SERVICE BULLETIN

MANDATORY**FIX ON FAILURE****INFORMATION ONLY** **Ref: SRV - 013- 002****Date: March 8, 2013****Product: Model Year 2012-- Grain Belt Header****Re:** Auger drum clearance.**Problem:** Drum contacting the carriage head bolt on the right hand side of adapter shell.**Solution:** Inspect for contact, if required replace carriage bolts and install kit assembly as per instruction below.**Ordering Information:** 1 - 94643 ADJ BOLT ASSY-AUGER ADAPTER**Labor Allowance:** N/A

**BEFORE****AFTER**

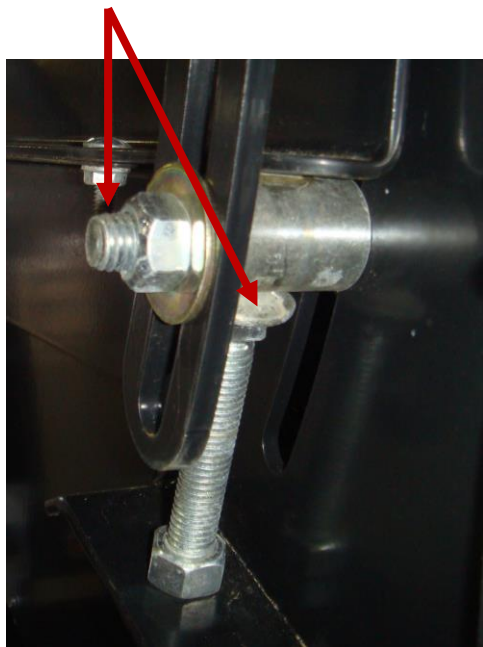
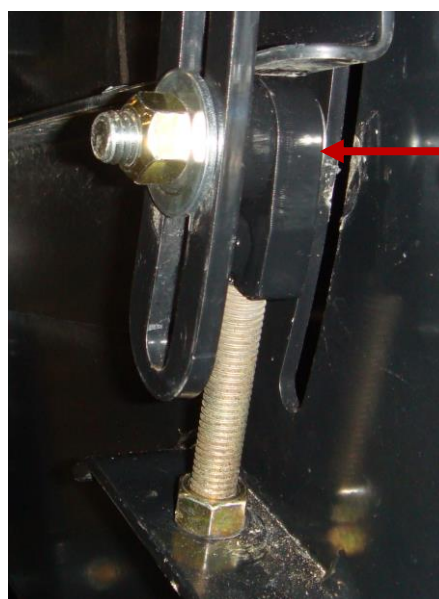
REMOVE CARRIAGE HEAD
BOLTS AND SPACER.

REPLACE SPACER &
BOLTS WITH
ASSEMBLY
SUPPLIED #94643.
Note: new
hardware does not
extend through
adapter shell.
